REPORT SUMMARY

REFERENCE NO - 19/506112/FULL			
APPLICATION PROPOSAL Conversion of Heritage Threshing Barn to residential, including the demolition of modern pole barns and erection of single-storey extension to side and erection of detached triple garage (part retrospective)			
ADDRESS Bletchenden Farm Bletchenden Road Headcorn Ashford Kent TN27 9JB			
RECOMMENDATION : REFUSE for the reason set out in Section 8.0 of the report			
SUMMARY OF REASONS FOR RECOMMENDATION The principle of the conversion of the existing barn to residential is considered acceptable, however the proposal includes a large side extension which is unjustified insofar as it would require major reconstruction to extend and alter the existing barn and would be harmful to the character and appearance of the countryside by the resulting form of development that would elongate the existing barn, harmful to its contribution it makes to the character and appearance of the countryside. Cumulatively with the proposed detached garage the proposal would result in an unwarranted form of development which would introduce excessive built form which would compete with the existing curtilage listed barn and result in the ov

Previously approved

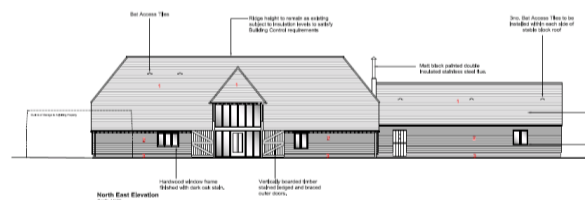
- 6.13 Where the proposal differs from the earlier consent is the size of the proposed extension to the side, together with the addition of a detached garage. The proposed extension would effectively be doubling the size of the previously approved scheme, with the proposed garage introducing further built development onto the site. Below the front elevations show the existing (prior to demolition of the pole barns), approved scheme and the proposed scheme :

- 6.14 The proposed footprint of the dwelling would clearly be larger than the previously approved scheme. Allowing the extension on the earlier approval was weighed in favour of limiting the use of the loft space. The scheme would have provided three bedrooms at ground floor, together with a kitchen and living room and one further bedroom at first floor. In comparison to the proposed scheme which would provide the same accommodation at first floor, a re-arrangement of the three bedrooms at ground floor to provide an enlarged kitchen/snug in the footprint of the earlier extension and a guest suite, shower room and boot room in the enlarged extension.

with additional bulk and mass at roof level that would compete with the original barn. Planning policy generally does not wholly support extensions to converted buildings and it is not considered this case is any different. A fairly sizeable extension was permitted under the earlier approvals and there is no justification provided as to why an extension of a similar scale would now be unviable. Conversions of former agricultural buildings should preserve the character and appearance of the building, whilst recognising its former use. The extensions as proposed do not seek to achieve this, the building would appear as extremely elongated and have a 'sprawling' form, which does not reflect the barns simple rectilinear form. The extensions would be wider than the remaining original barn (with the barn measuring approximately 18m in width and the extension measuring 24m) and introduce varying roof forms and unacceptable additional bulk and mass.
